Illinois Department of Transportation

Memorandum

To: ALL BRIDGE DESIGNERS 19.3
From: D. Carl Puzey *D. Carl Puzey*
Subject: Revised provisions for Precast Prestressed Concrete IL
Beams and applicable I and Bulb T Beams
Date: March 25, 2019

**IL45-3838 SIMPLE SPAN LIMITS
(Strand Pattern/Span Length/Beam Spacing)**

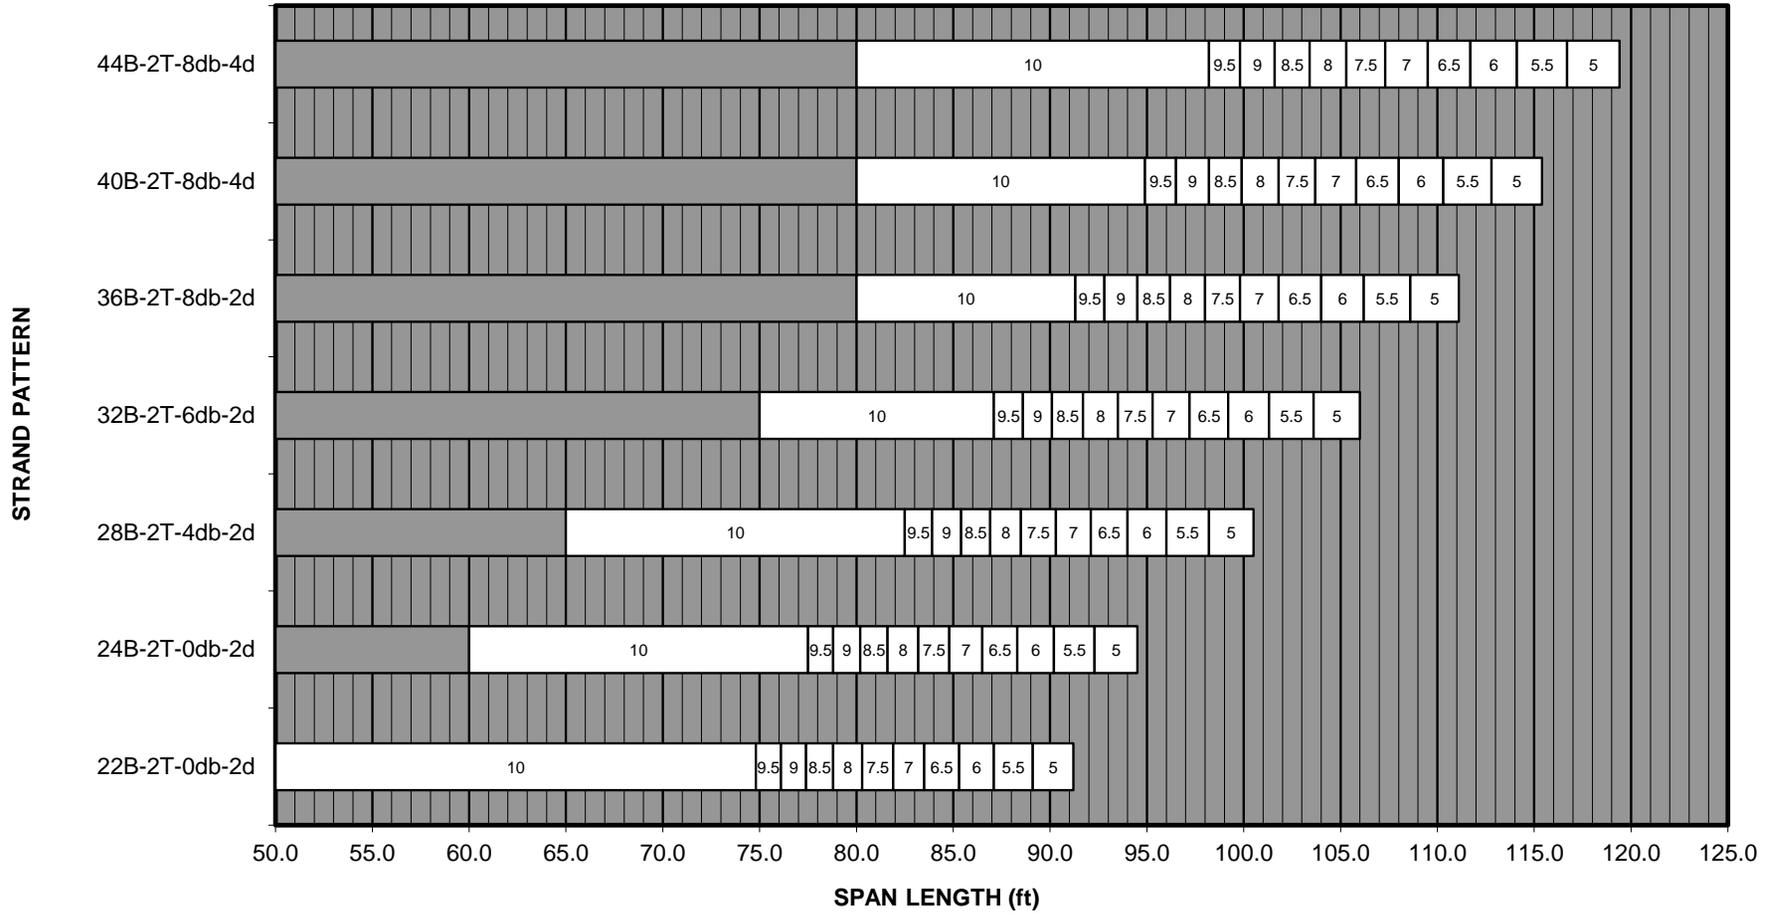
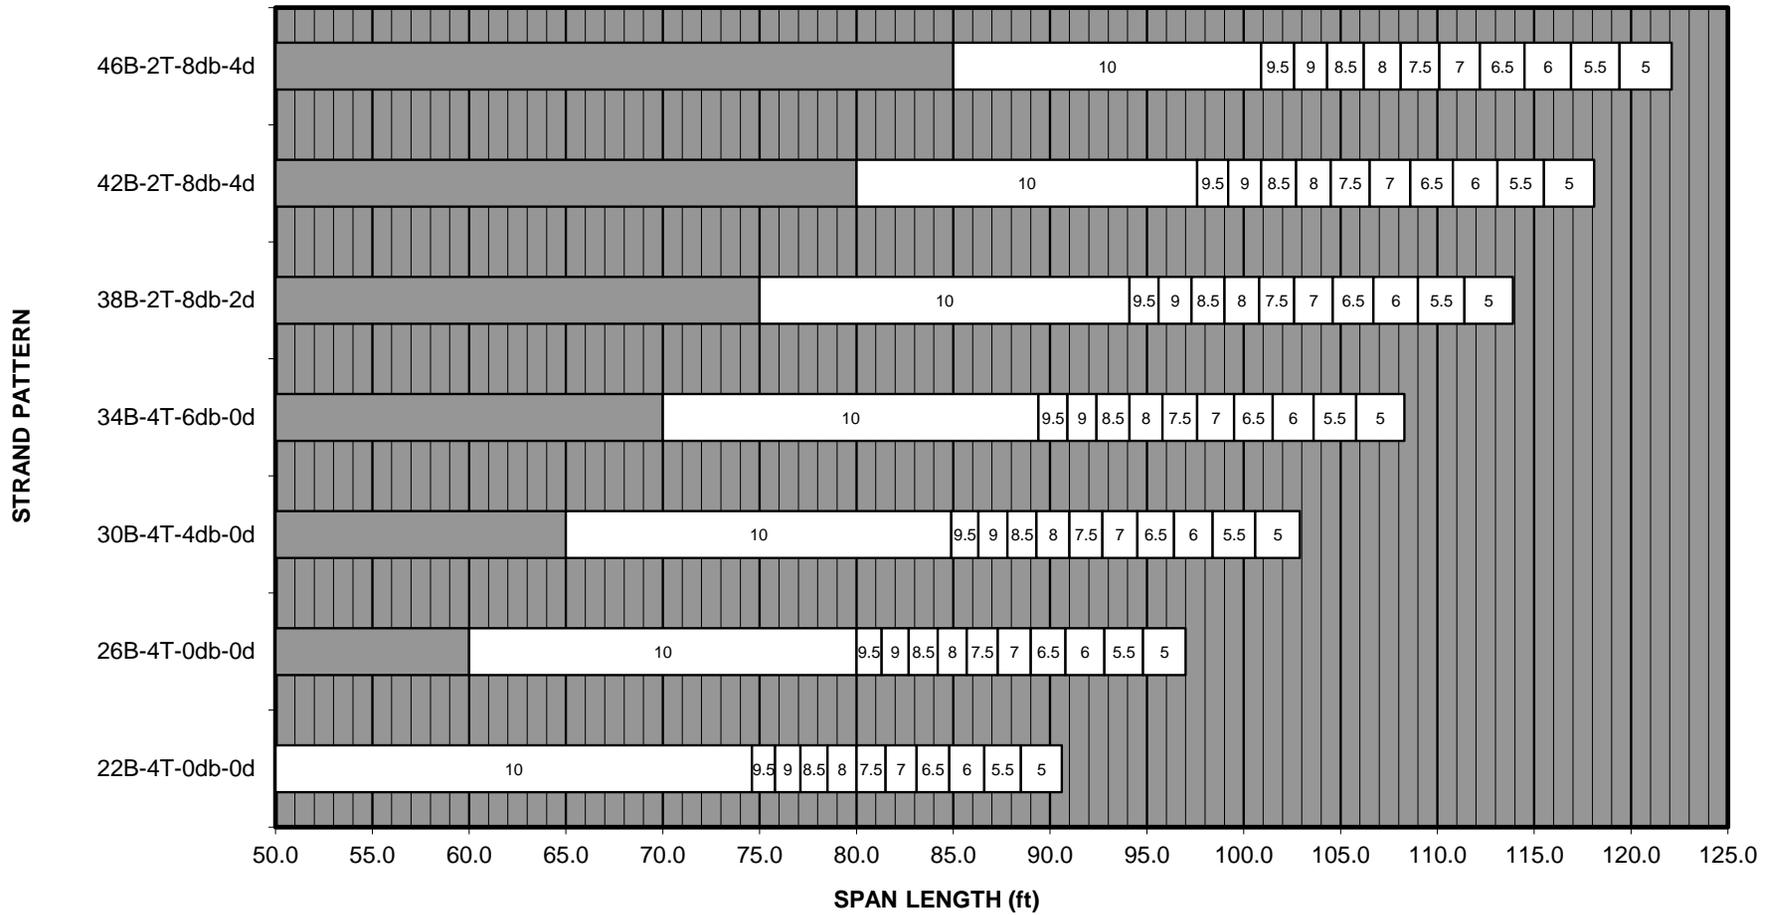
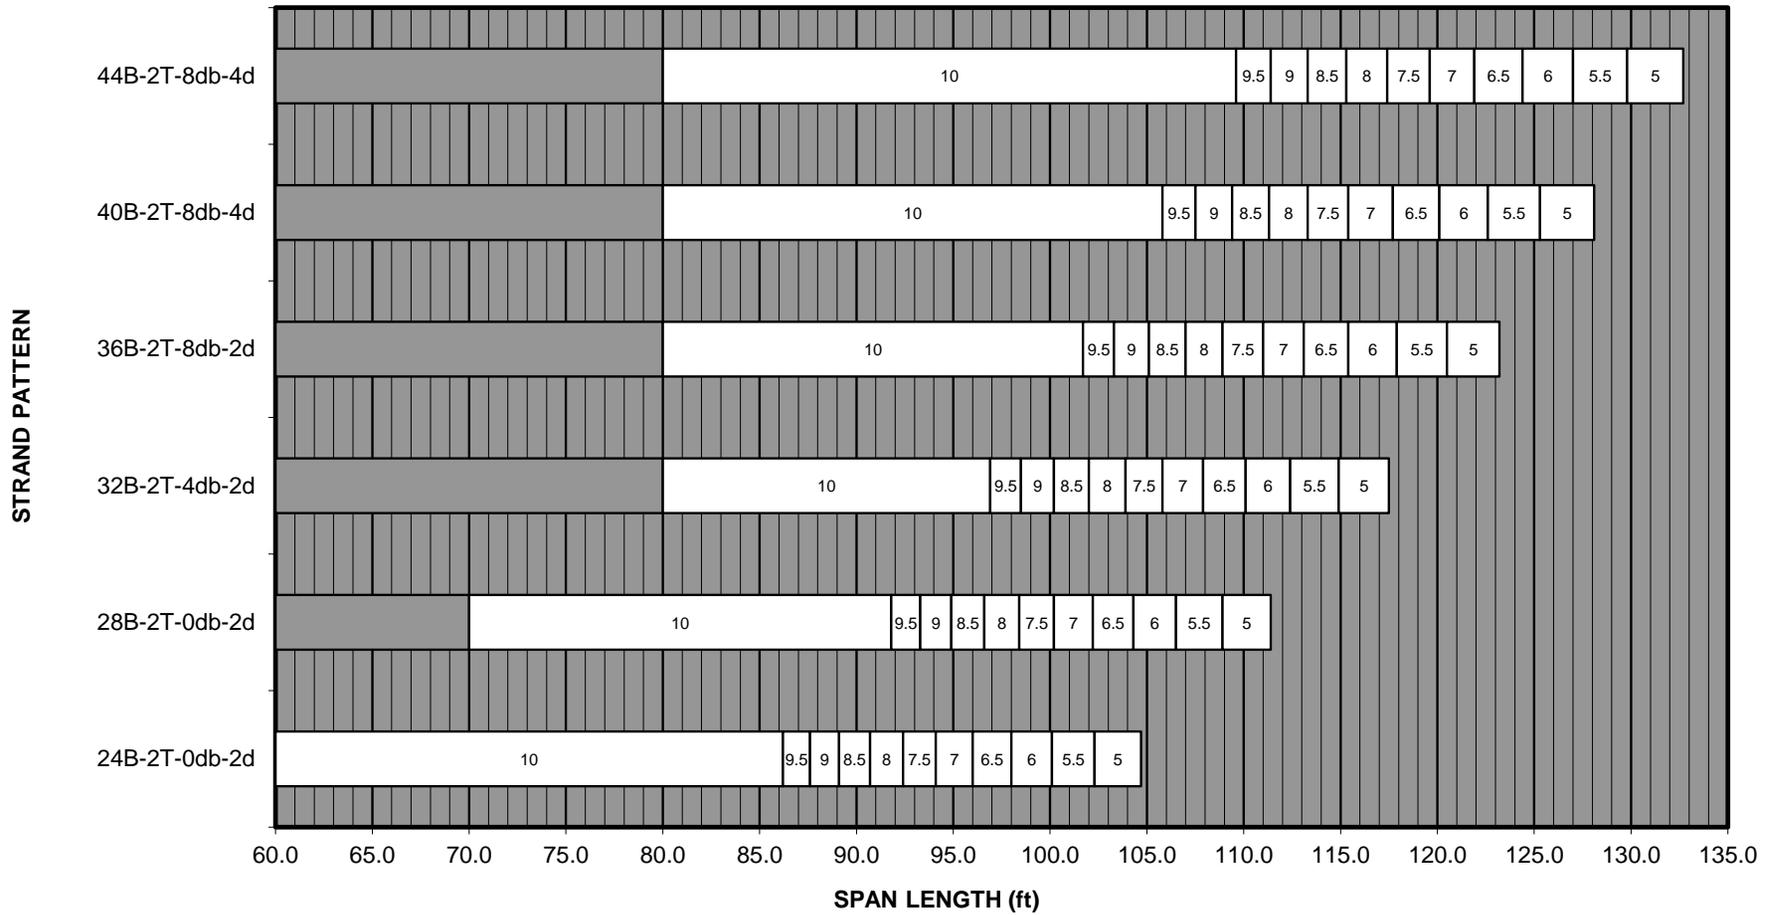
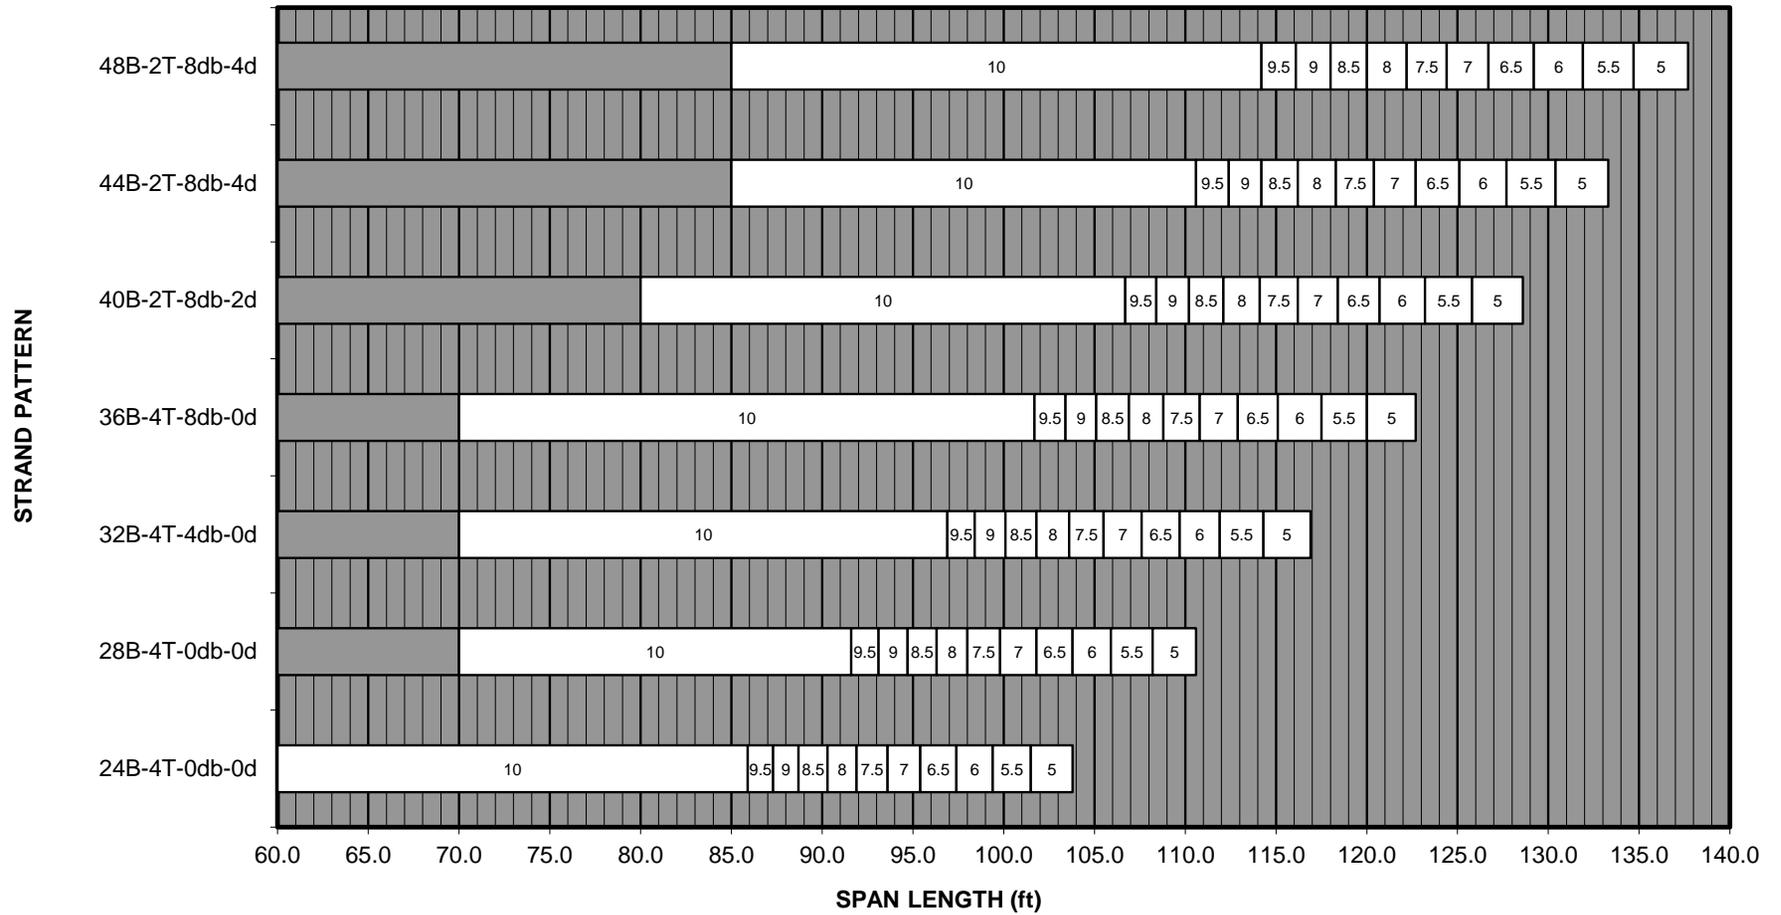
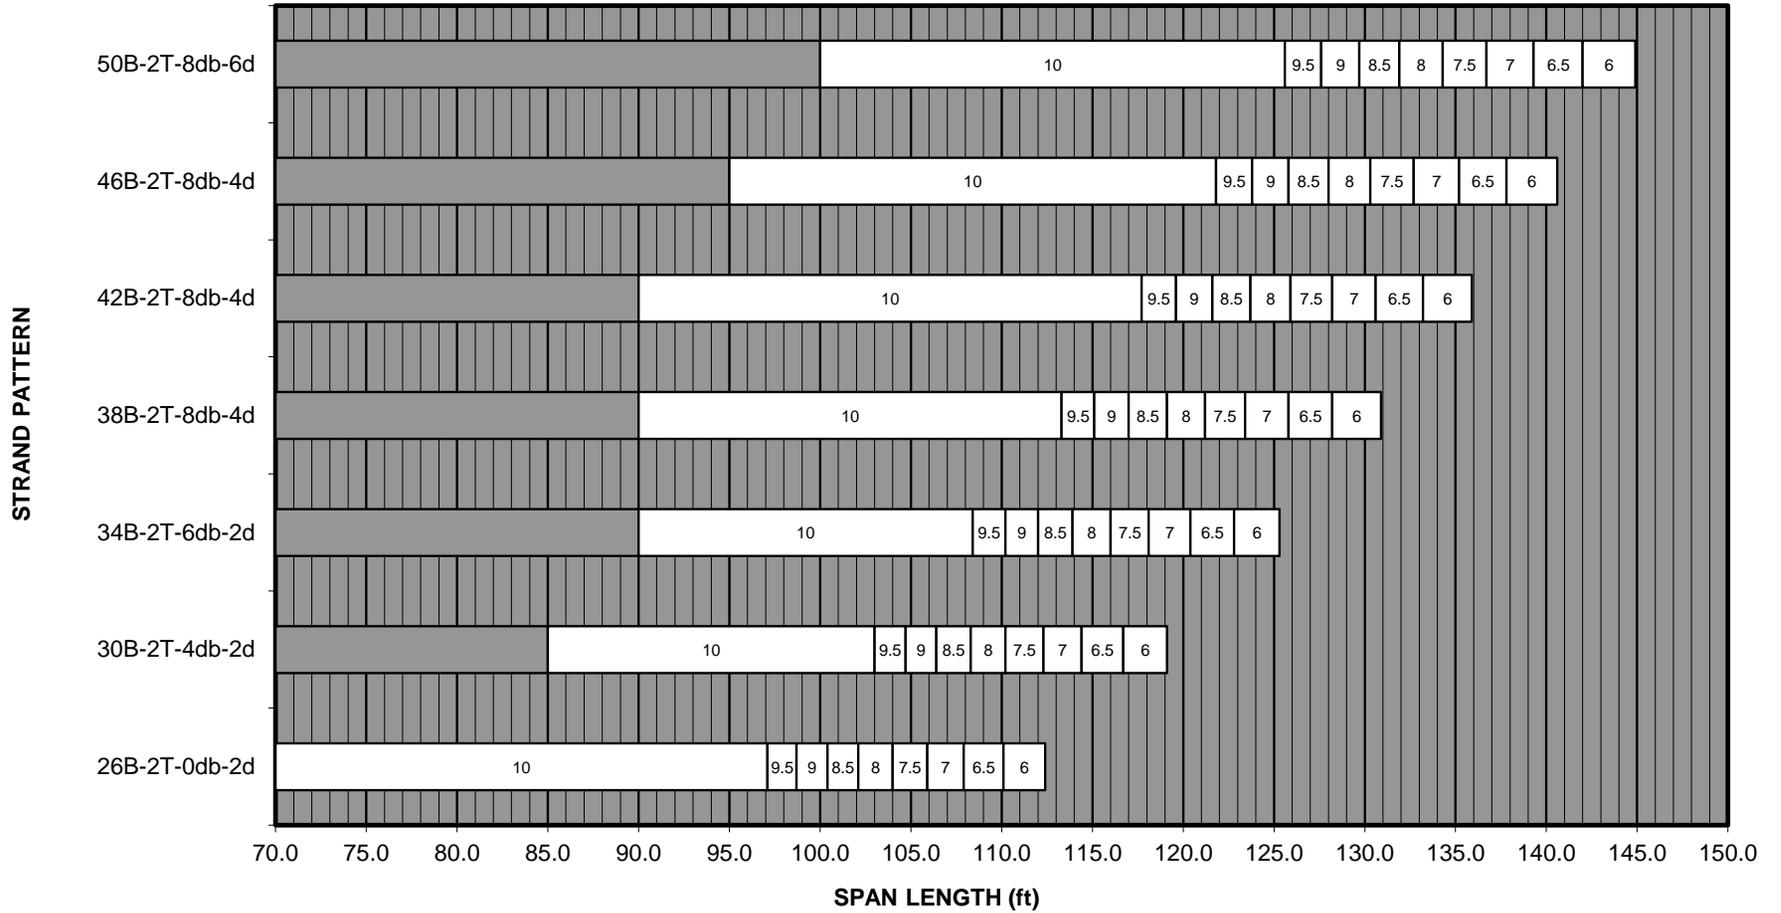
The Department evaluated our standard strand patterns and beam configurations for an f'_c of 6.5 ksi and found that the allowable span length for each beam depth would be reduced by an amount less than two feet. Therefore, the IL-Beam base

sheets have been updated to allow a concrete release strength of 6.5 ksi instead of 7.0 ksi and the Planning Charts, Figures 4 through 16 of ABD memorandum 15.2, have been updated with slightly reduced permissible span lengths. These charts are included in this memorandum.
